City of Portland, Maine - Building or Use Permit Application
389 Congress Street, 04101 Tel: (207) 874-8703, Fax: (207) 874-8716

Permit No: 02-396	Issue Date: JAN 15 2003	CBL: 397 D012001
----------------------	----------------------------	---------------------

Location of Construction: 155 Pineloch Dr	Owner Name: River Wood Construction	Owner Address: 72 Tide Mill Rd	Phone: 5516
Business Name:	Contractor Name: River Woods Construction	Contractor Address: 72 Tide Mill Road Portland	Phone: 2073294535
Lessee/Buyer's Name	Phone:	Permit Type: Single Family	Zone: R-2

CHECK-LIST AGAINST ZONING ORDINANCE

Topography & Site Plan
 Deepwood & Pineloch Drive, Portland, Maine

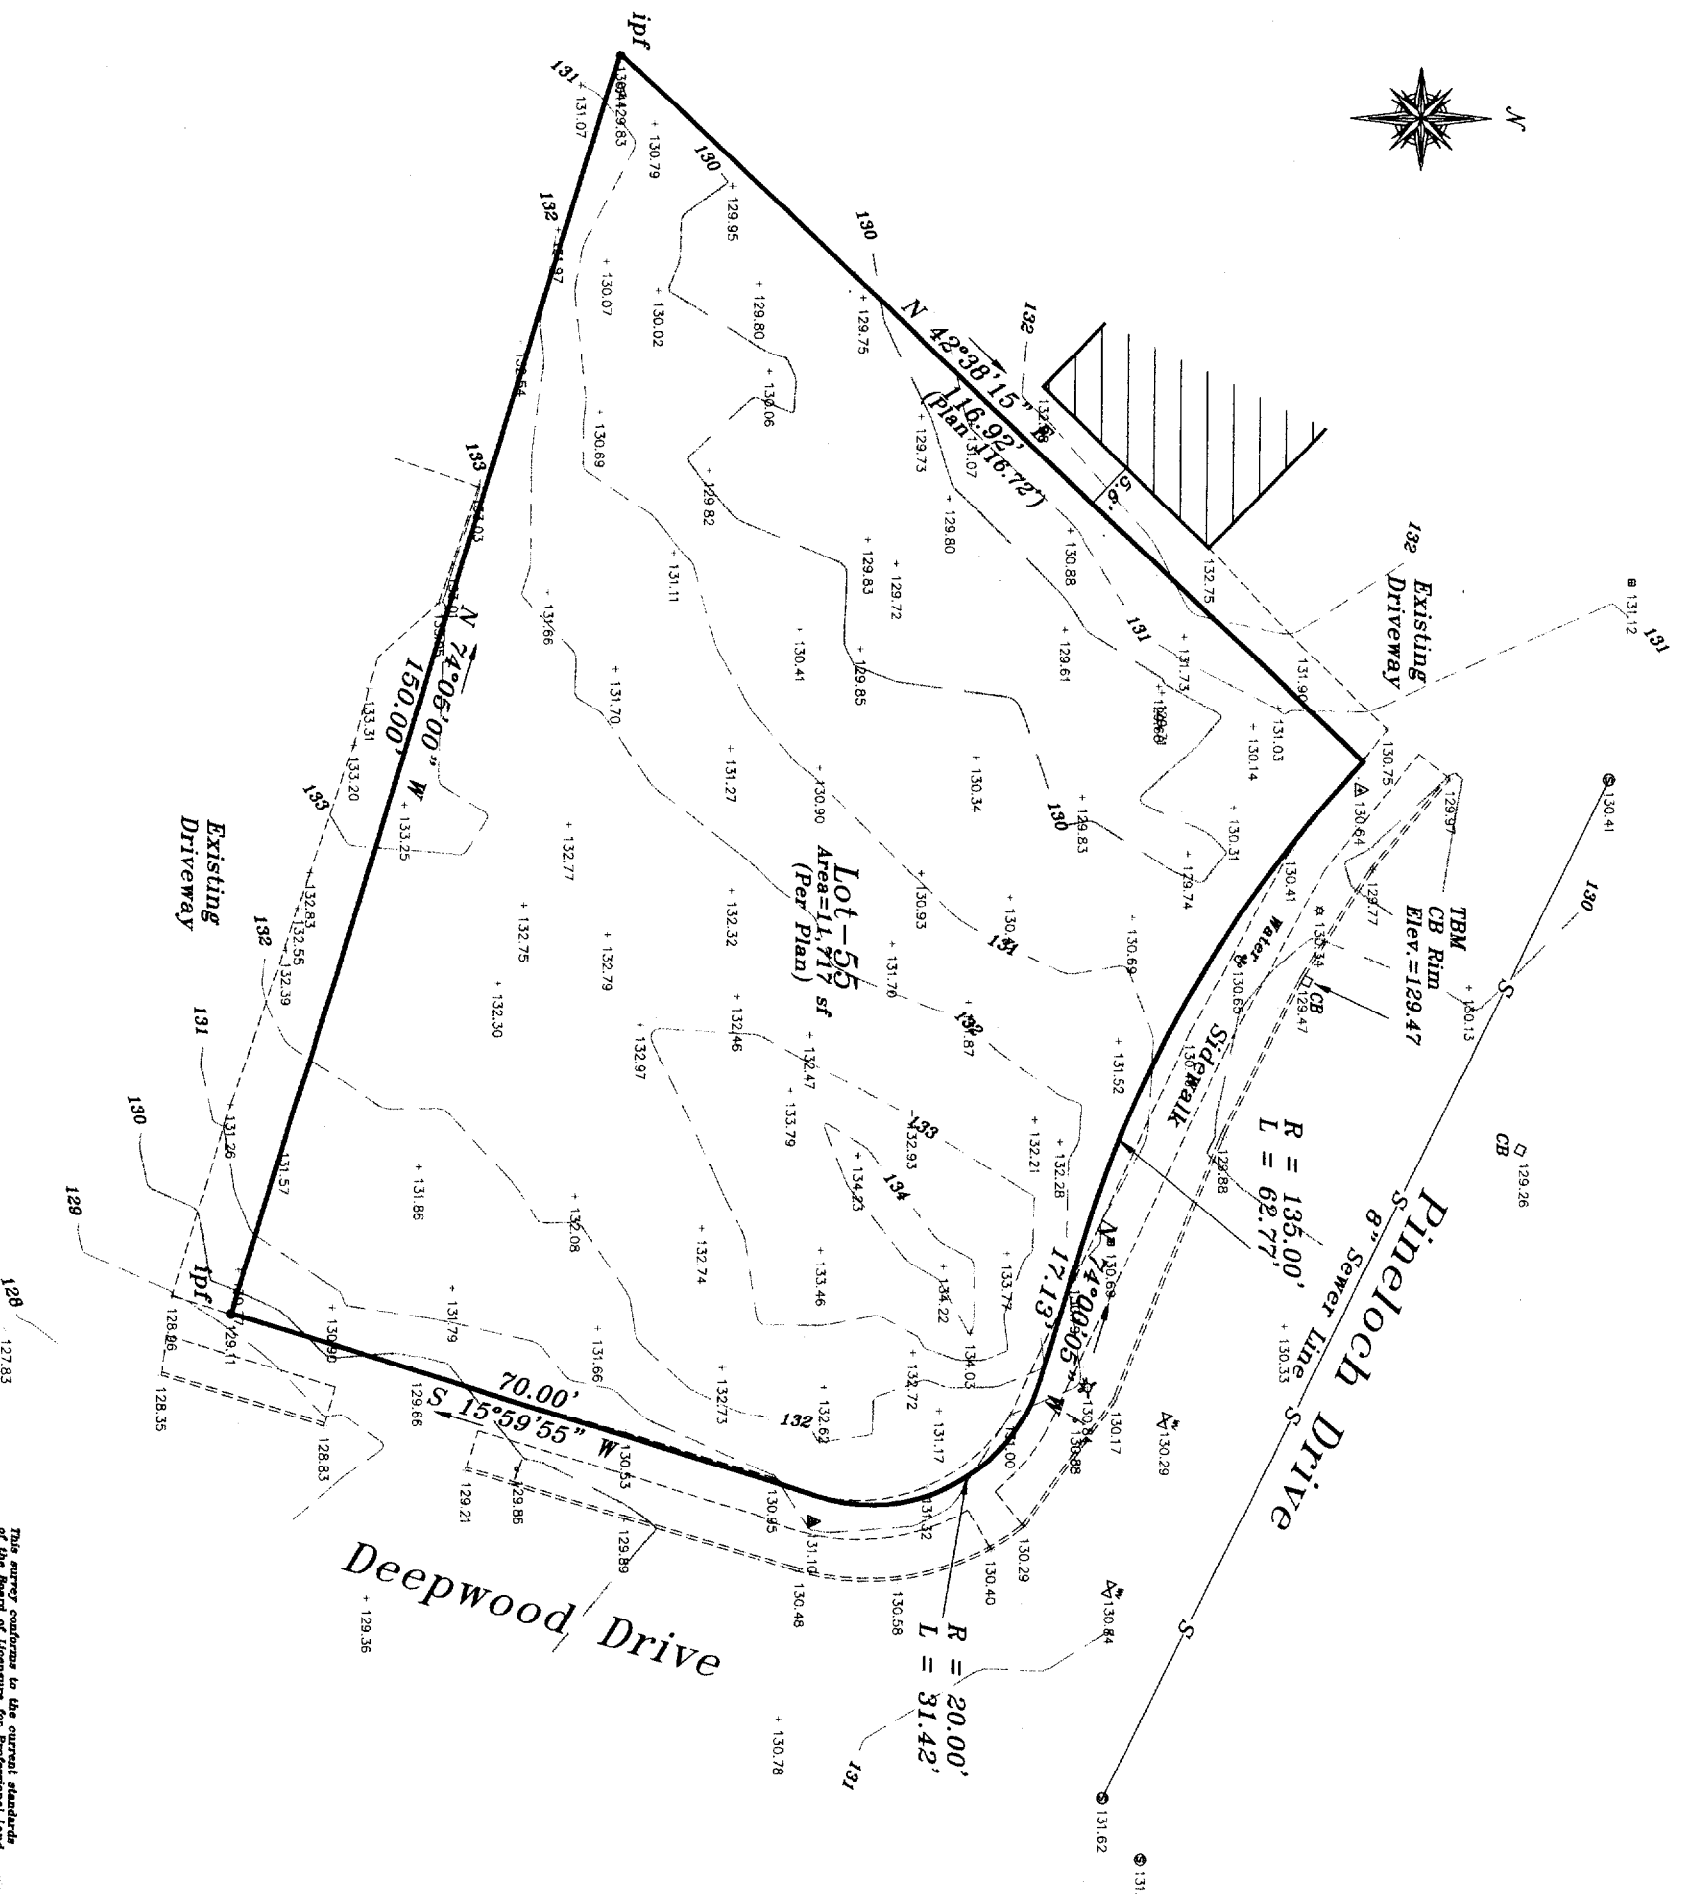
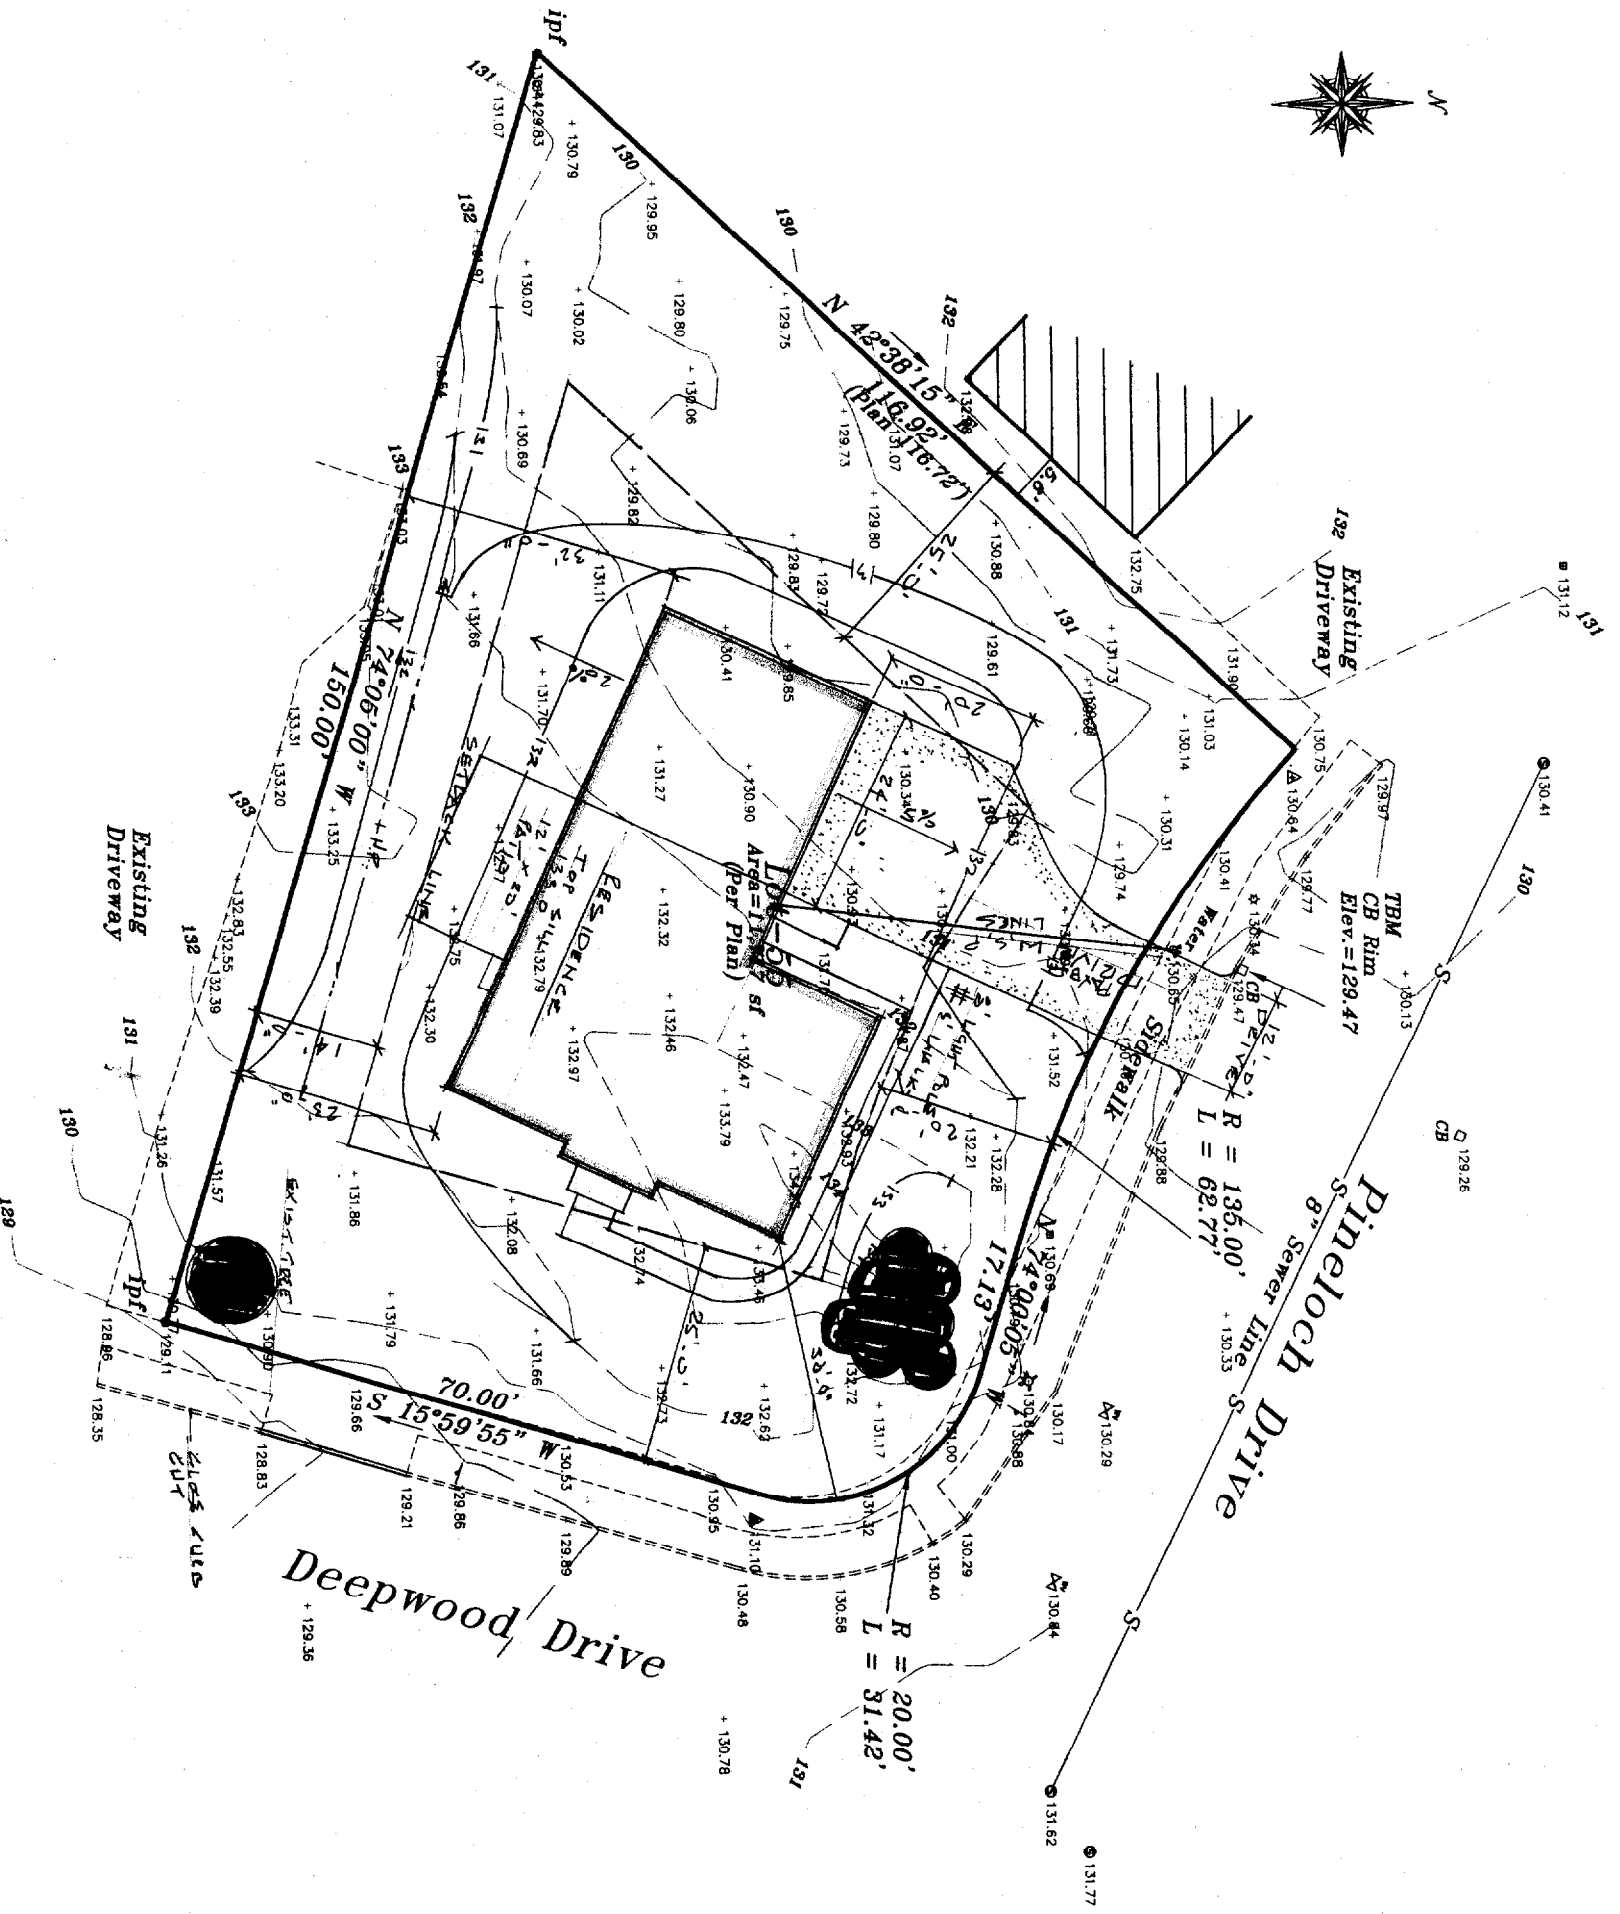
Proposed Use/Work - construct New 28' x 42' single family home with attached Garage
26' x 24'
NO DECKS
(side patio 12' x 20' only)
NOT A STRUCTURE

Lot Street Frontage - 50' req - 100' shown

(Along Deepwood Drive)
Front Yard - 25' min req - 26' scaled to stairs

NO DAYLIGHT BASEMENT

Rear Yard - 25' min req - 28.5' scaled

Side Yard - 2 story 14' min req - 23' shown

Side yard on side st - 20' min req - 26' scaled

Width of Lot - 80' req - ~~88' scaled~~ 88' scaled (between Pine Loch & Side yard)

Height - 35' min - 24.75' scaled

- 1) No DAYLIGHT BASEMENTS are shown and therefore, no daylight basements have been approved.
- 2) NO REAR DECKS have been shown on any plans. A 12' x 20' PATIO has been shown in the side yard. Please note that at patio is not a built structure. If this patio turns into a built structure, such as a deck, IT SHALL BE REQUIRED to take out a separate permit.
- 3) Separate permits shall be required for future decks, sheds, pools, and/or garages.
- 4) This permit is being approved on the basis of plans submitted. Any deviations shall require a separate approval before starting that work.
